Proposed Strategic Housing Development at Dunshaughlin East, Co. Meath

Stage 1-2 Quality Audit

- 1.1 Title** **QUALITY AUDIT DUNSHAUGHLIN S1-2**
- 1.2 Audit Reference Number** **QUALITY AUDIT DUNSHAUGHLIN S1-2 KS 290**
- 1.3 Project Code** **DUNSGEMTIA**
- 1.4 Date Audit Completed** **4th December 2018**
- 1.5 Audit Attended By** **Ken Swaby**
Mark Andrews
- 1.6 Audit Team**
 - Team Leader** **Ken Swaby, ILTP**
 - Team Member** **Mark Andrews, ILTP**
- 1.7 Information Received**

Figure 4.1: Proposed Open Space Area and Adjoining Road Network (Source: JOR Drawing Road Signage & Markings Layout Plan Sheet 1 of 3, ref. 032, rev. 3)

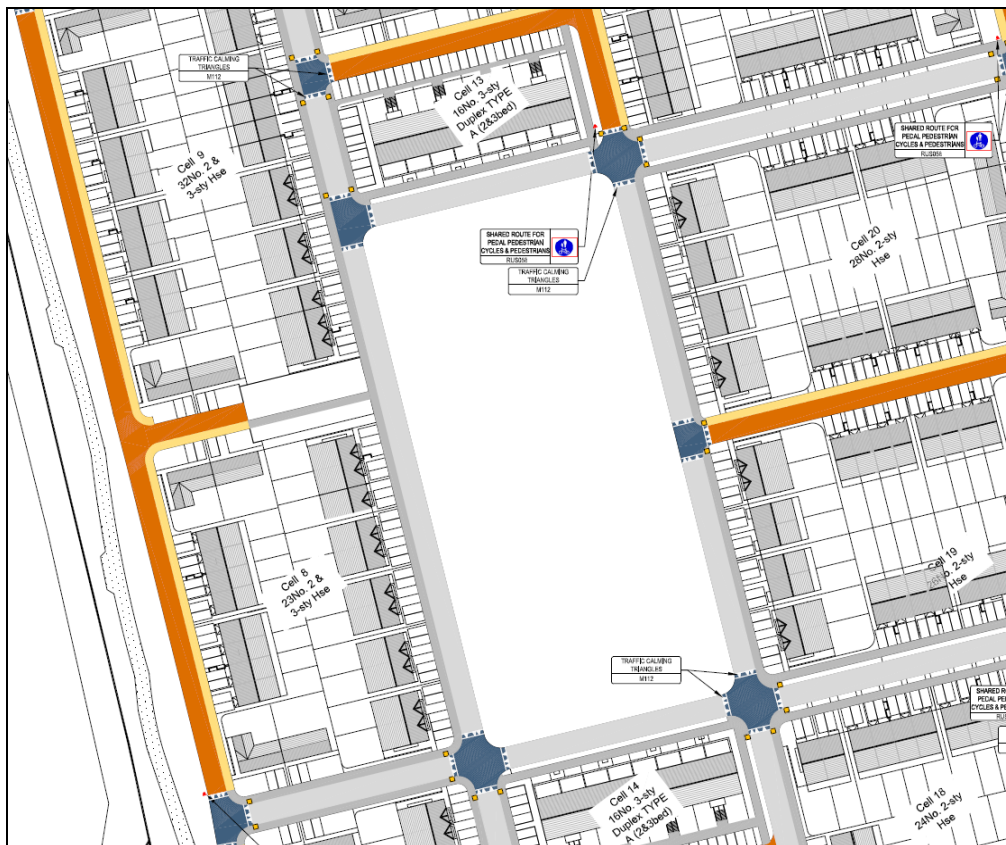
The drawings provided for audit indicate an Open Space area to the northwest of the proposals, but do not appear to include pedestrian access facilities in this area, such as footpaths adjoining the surrounding streets (refer Figure 4.1). Inappropriate or insufficient pedestrian facilities linking the proposed Open Space area and adjoining road network may potentially lead to non-motorised users entering the carriageway at an inappropriate location or time and coming into conflict with motorised traffic.

It is recommended that the design team ensures that appropriate pedestrian facilities are provided within and around the proposed Open Space area.

4.1.2	Y	Y	The design team agree with the recommendations. Pedestrian facilities linking the proposed open space area and adjoining road network will be incorporated in the scheme.	Y
